Dwelling type:	House and Garage.
Dwelling configuration:	Single Storey.
Nature of works:	New Building.
Stage of inspection:	Final.
Construction Type:	Brick Veneer.
Garage:	Attached.
Foundations:	Slab.
Builder:

Schedule of Defects:

Defects, observations and other related comments from the Final Inspection on the 26/04/2021:

Figure 3.2.2.3

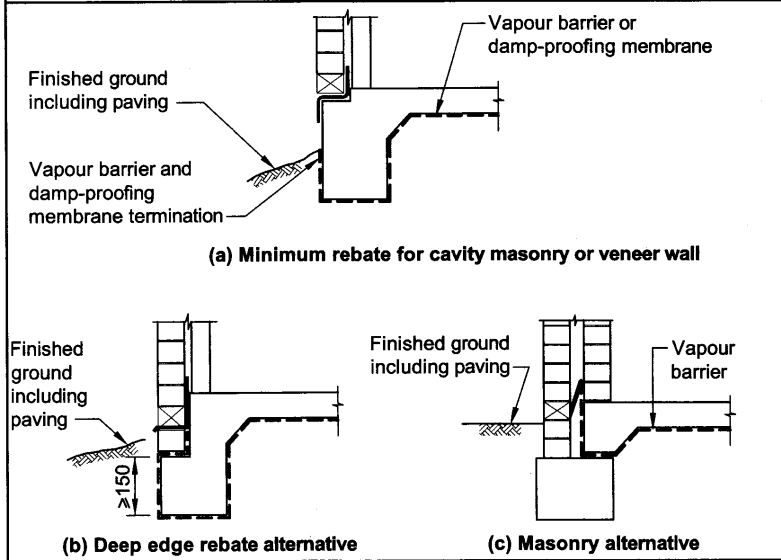
The polyethylene vapour barrier from beneath the concrete floor slab has not been turned up the external side faces of its edge beams. It must be prior to them being back filled up against, which will allow moisture ingress via slab edge dampness into the internal timber wall skins and/or the floor coverings if not done.

It is a requirement of Part 3.2.2.6 Vapour Barriers of the BCA that *'The vapour barrier must be placed beneath the slab so that the bottom surface of the slab is entirely under laid and extends under edge beams to finish at ground level in accordance with Figure 3.2.2.3.*

All the existing loose fill that has been placed up against the slabs edge beams will need to be removed and the polyethylene vapour barrier properly extended up the external side faces of the edge beams to at least the height of future finished ground level or paving i.e., 75mm below the damp-proof course and bottoms of the weepholes, after which any termite barriers that are in place, if required, will also need to be properly installed.

WAFFLE FOOTING OPTION

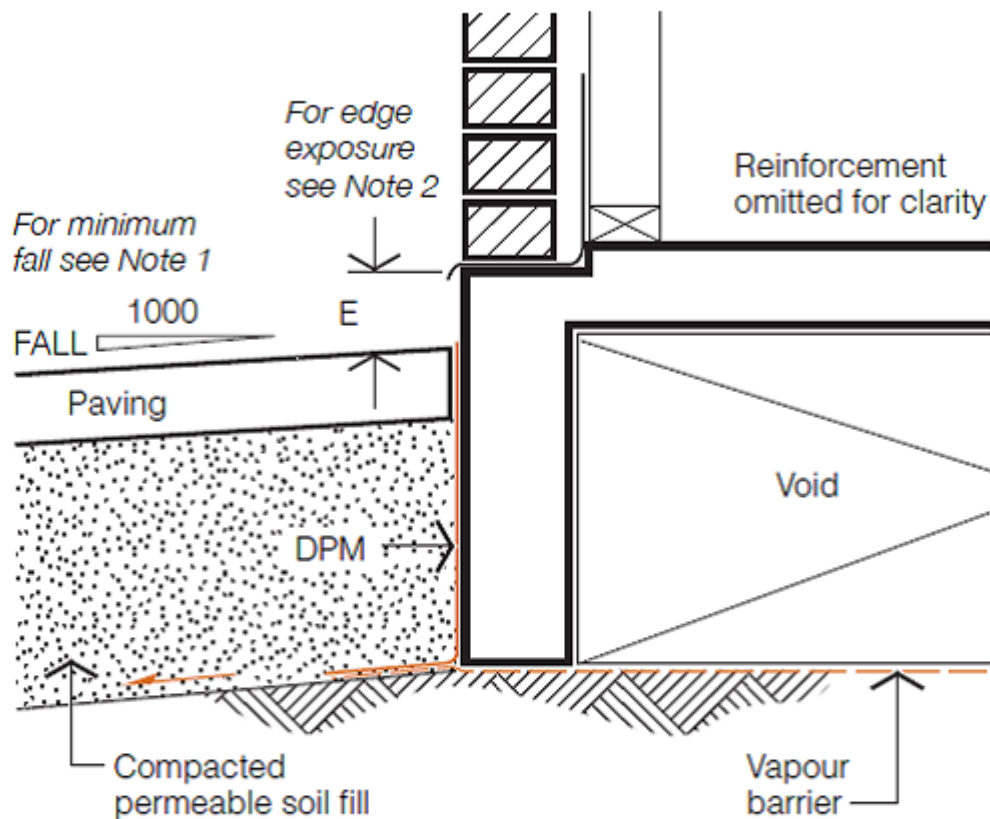
- 6) This is a defect because the vapour barrier does not extend under the edge beam to finish at ground level as required in the BCA.

Extend the vapour barrier around the perimeter of the building so it finishes at ground level as shown in Figure 3.2.2.3 of the BCA.

- 1 Fall 'cut' benching away from the footing
- 2 Terminate vapour barrier under DPM on 'cut' benching

- 3 Place DPM between paving and footing (see Note 3 for details)

Figure 3.1.3.2 Site surface drainage

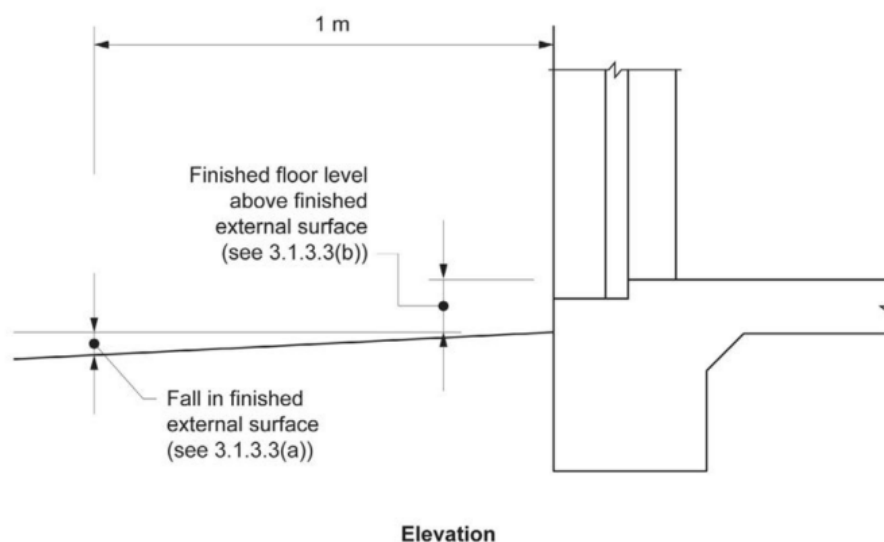
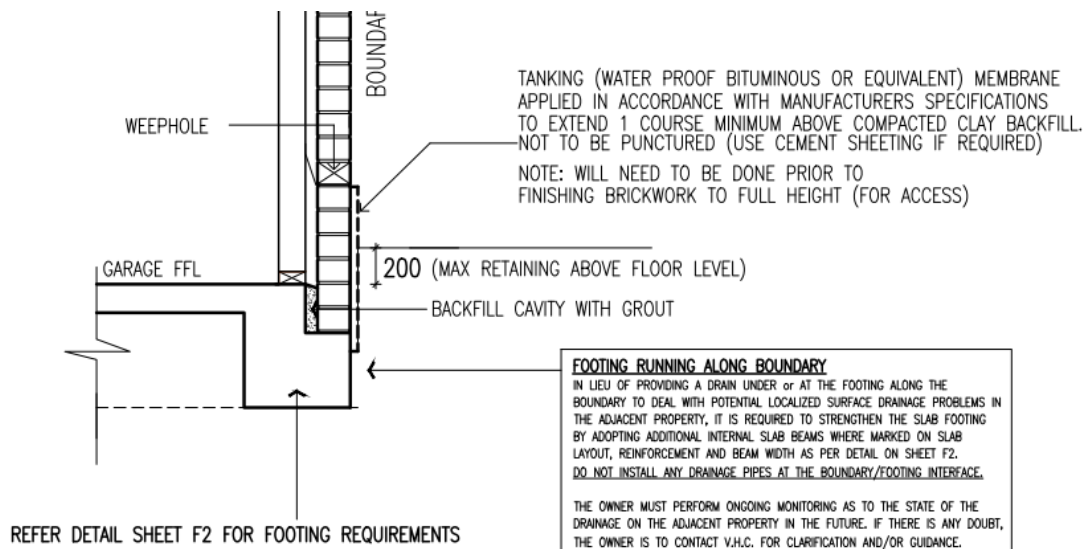
The land to the garage falls back towards the foundations of the slab. Given that this is a zero boundary, the builder must work in provisions for draining the soil to this area.

I noted that the Engineering states that a 50 mm fall away from the footings must be installed. The builder needs to assist us with an understanding of how, with a zero boundary the builder expects to achieve this requirement.

The NCC mandates that water is controlled and must fall away from the dwelling. See part 3.1.2.3 and figure 3.1.2.2.

The builder should have allowed a 150 mm set back to the Garage wall to boundary and installed a water management system to divert water away from the foundations and slab edge as an alternate solution to the mandated requirements.

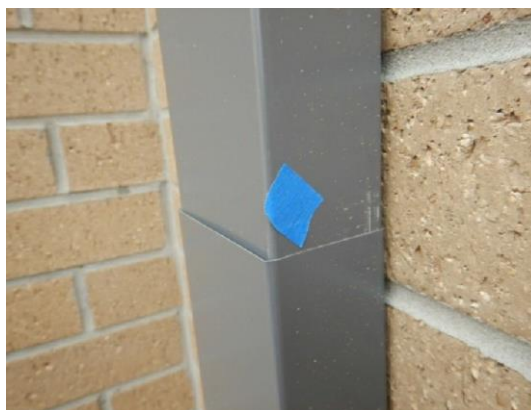
The BlueScope Colorbond roofing products to the dwelling have been damaged during construction.

Damaged areas greater than 2mm in width will need to be replaced.

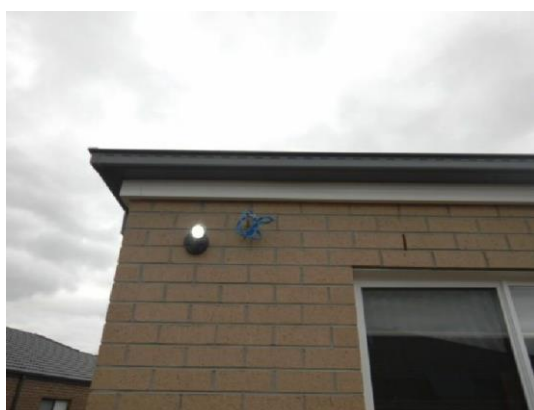
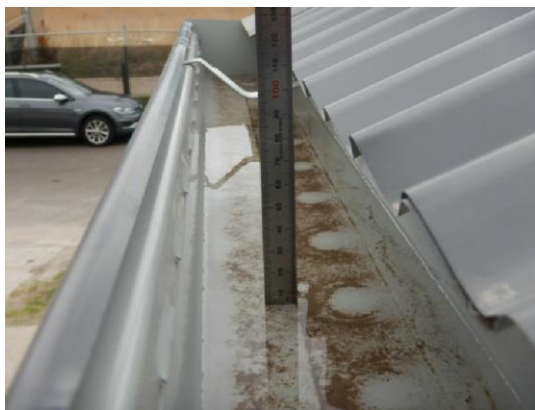
AS 3500.3: - The minimum allowable gradient is 1:500 to achieve an effective gradient with no permanent ponding.

Areas of the eaves gutter installation to this dwelling have not met this requirement.

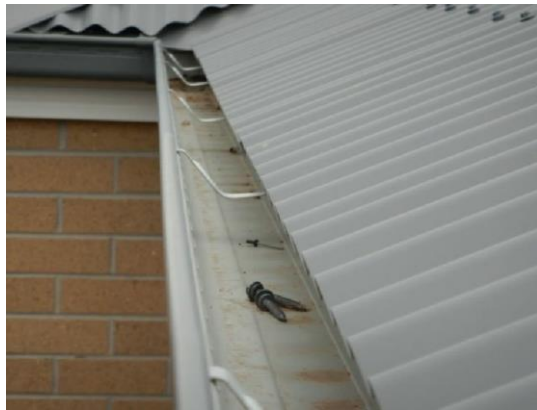
Standards Australia HB 39: - The gutters and roof sheeting must be fully cleaned of metal particles, roof screws, pop rivets, mortar, paint, and the like.

The roof and gutter installation to this dwelling has not met this requirement.

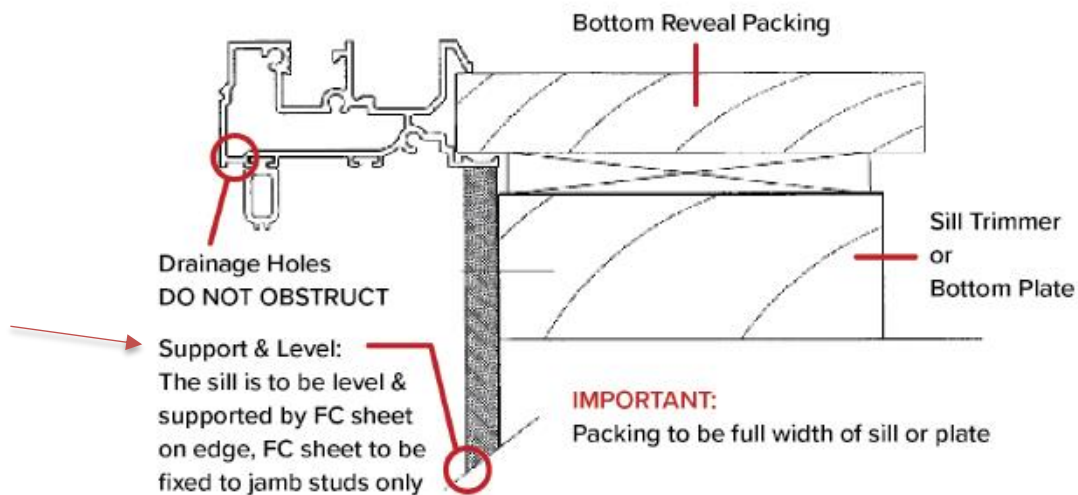
Some of the bottom reveals too wide windows are presenting with significant fall back towards the window.

Many window manufactures require a 7 mm cement sheet or pine board strip placed in the cavity to support the heavy glazed section; this was not present at the time of inspection. This often also results in bows to the top styles long after the windows are installed.

FIGURE 4.2.2(A) ASSESSING FRAMING TOLERANCE

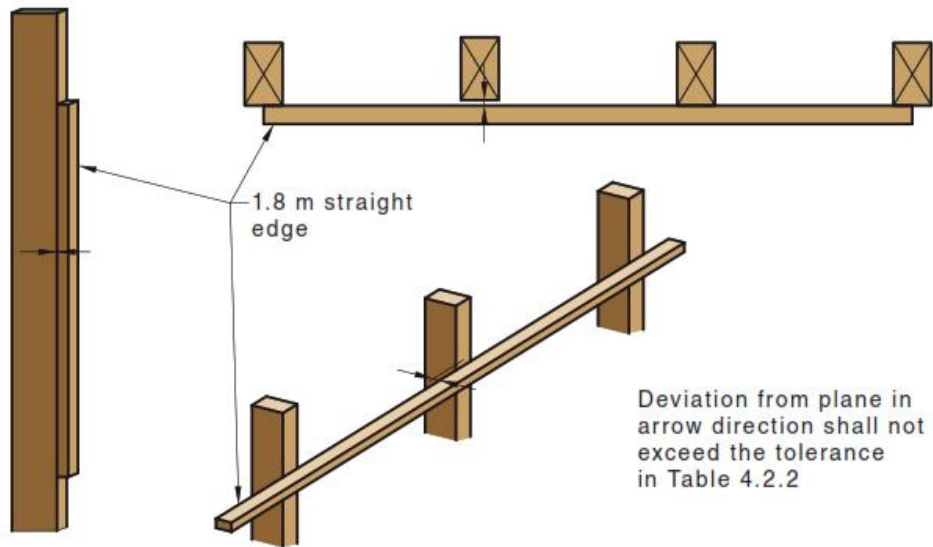
There are a number of areas in the home that exceed the allowance of 4 mm tolerance over 2 m.

As stated, the acceptable allowance is 4 mm over 2 m. These walls will need to be reworked to ensure that the builder complies with this requirement.

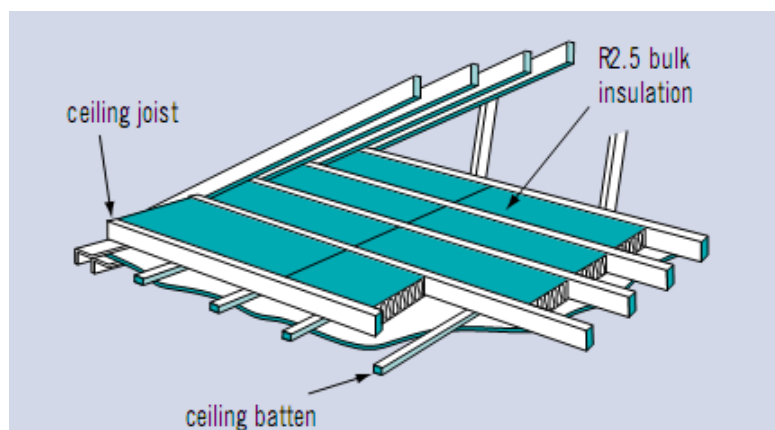
- Large areas of ceiling batts have been left out around the ducts and exhaust fans. The batts will need to be installed snug to the ducts and just clear of the fan outlet.
- Batts have been installed over pipes wires and timber. The 90 mm plus gap between the top of the plaster and the bottom of the batts is making all installed batts that have this gap completely ineffectual. The R rating on the dwelling has been greatly reduced and the overall performance of the roof installing does not meet the requirements of the energy report on the dwelling. The whole roof will need to be reworked so that all batts are installed hard to the plaster with no gaps or holes to the installation.
- Other trades appear to have removed batts from their work areas with little regard for the information inserted below. Note that batts must be installed up to the 50 mm area around protected down lights.

The insulation needs to be reworked so as to be installed in a manner that complies with AS 3999 with all areas covered and the batts flush to the top of the plaster.

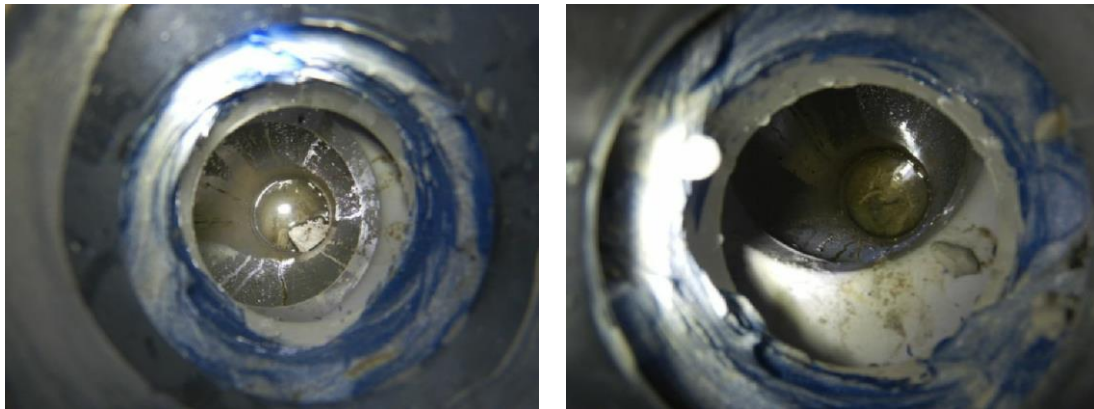
The shower wastes and floor waste gullies are presenting with an amount of trade waste.

FIGURE 5.4.3 TYPICAL ISOLATION JOINT

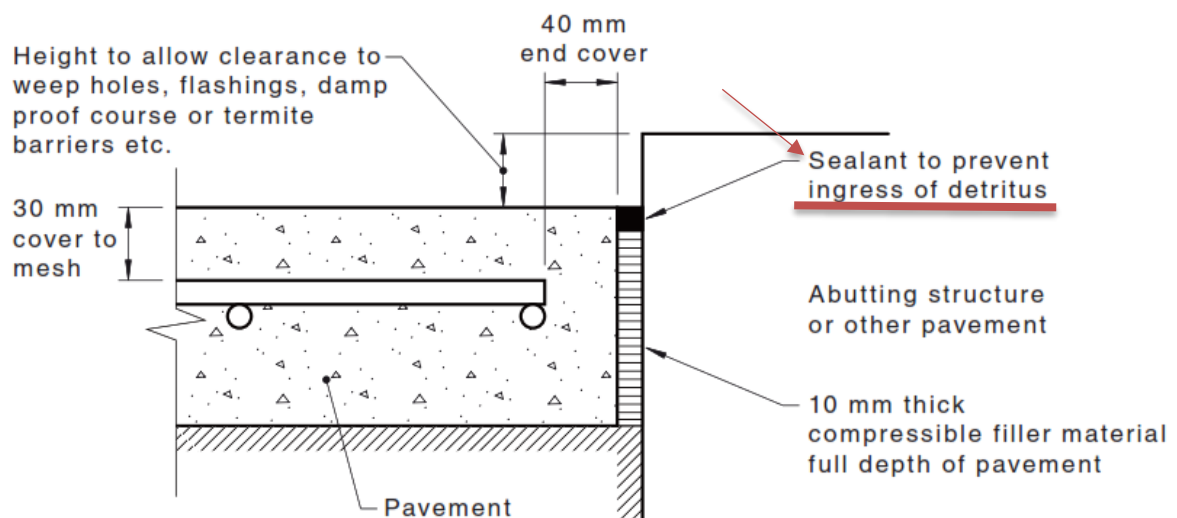
It was noted the concrete paving has not been caulked to the dwelling at the isolation joints. This caulking will need to be completed in accordance with AS 3727.1, figure, 5.4.3.

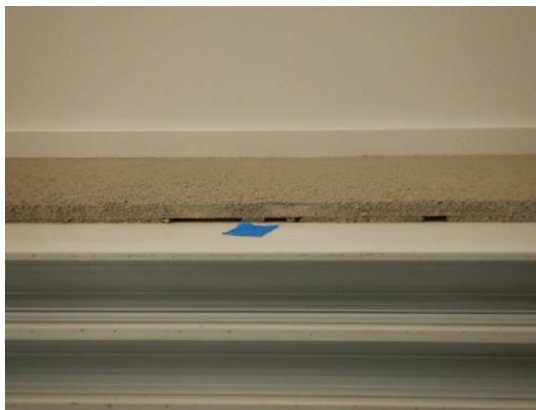
The powder coat finish on aluminium frames has been damaged through the finished coating. The damage could have been avoided with appropriate protection and care. Individuals are often tempted to spray over the scratches with an aerosol lacquer, which is an inferior product. Acrylic lacquer is soft and offers only moderate durability to ultraviolet, pollution and general dirt and grime. Also, the layer of chromate has not been replaced, which greatly reduces the durability of the coating. Dark colours will fade after moderate UV exposure. If this occurs, we recommend our clients use this paper trail to seek replacement, at that time.

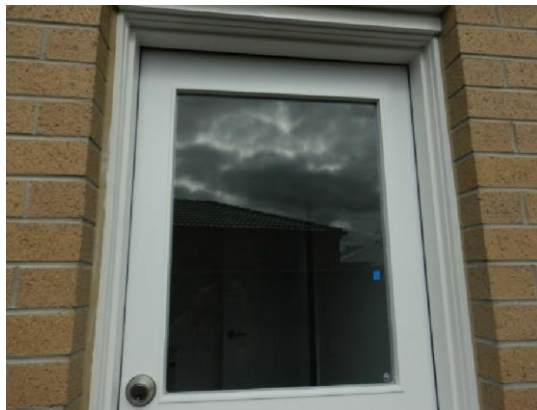
The Victorian Building Authority: - Calls for all glass to be protected during the build. Allowance is made for minor damage. This dwelling glass in parts exceeds the allowance stated in the VBA advice below.

Given this item can be difficult to see, it can be assumed not all areas have been marked. The owner and builder will need to check for additional scratches in different lighting conditions.

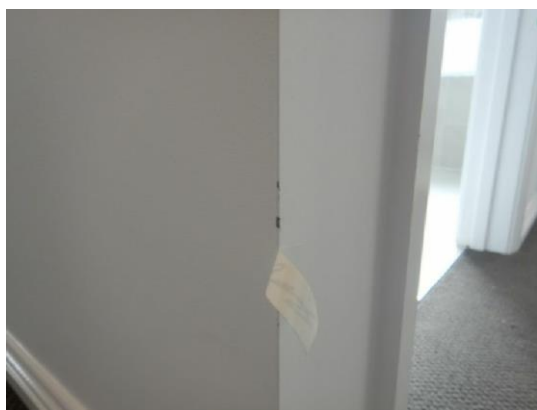
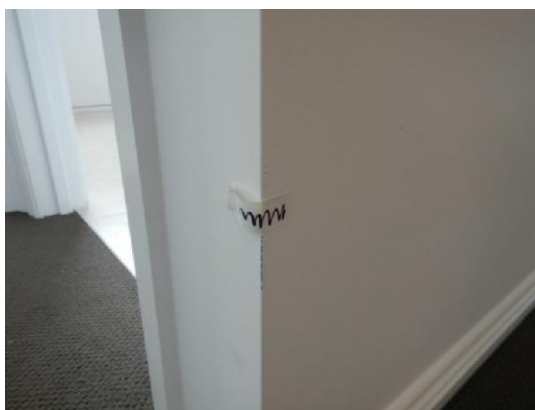
Painted areas have not met these requirements.

Defect noted through out dwelling, refer to tape on site.

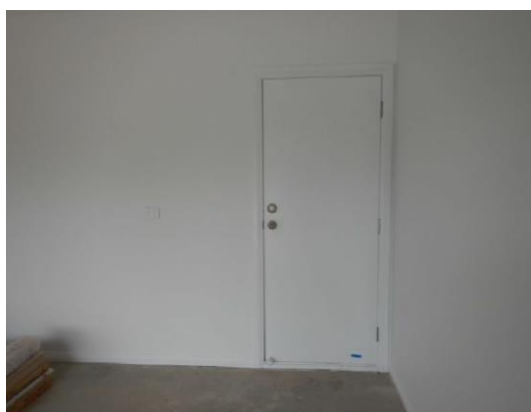
A number of door margins will need to be reworked to comply with the inserted.

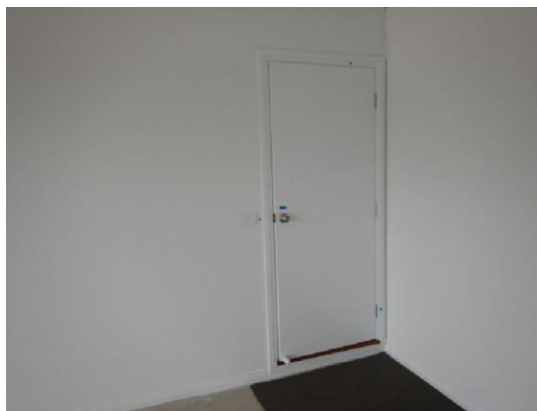
A number of doors will not latch closed, others when closed rattle. All door furniture must operate as intended; the builder will need to ensure all areas are compliant.

FIGURE 15 TYPICAL SEALING OF SINK TO WORKTOP JOINT

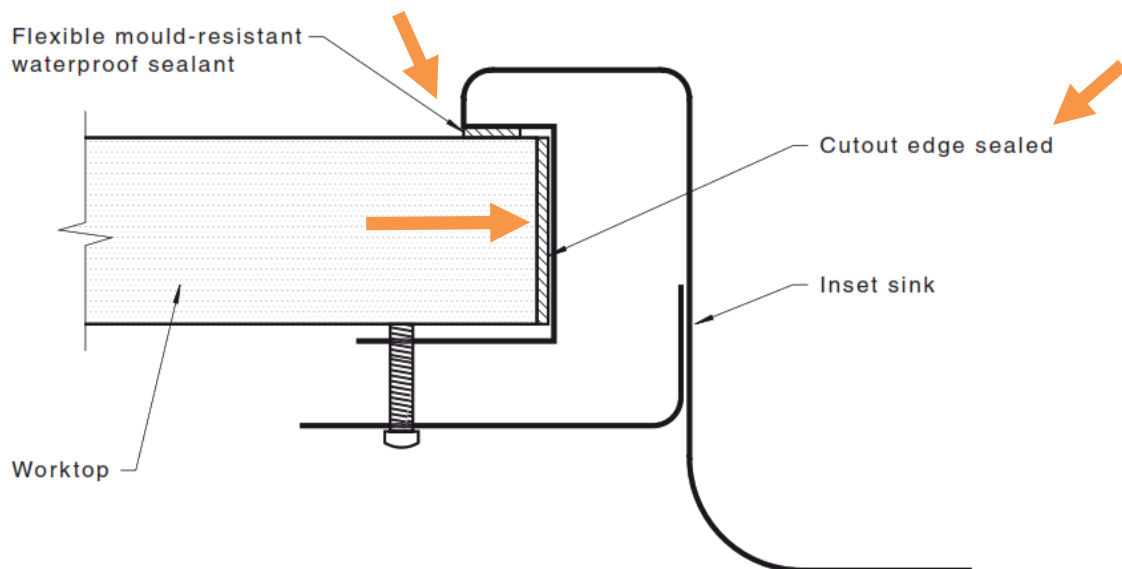
AS 4386, part 11.4: - Mandates all sinks to be sealed to the benchtop. The Victorian Building Authority advise to all builders is to seal all sinks, basins, and benchtops. When cutting out or drilling into the benchtop, the cut-out area must also be sealed. The restriction of water into the benchtop material is mandatory. See inserted from the VBA and the Standard. This dwelling fails these requirements. Extract As 4386, part 11.4.
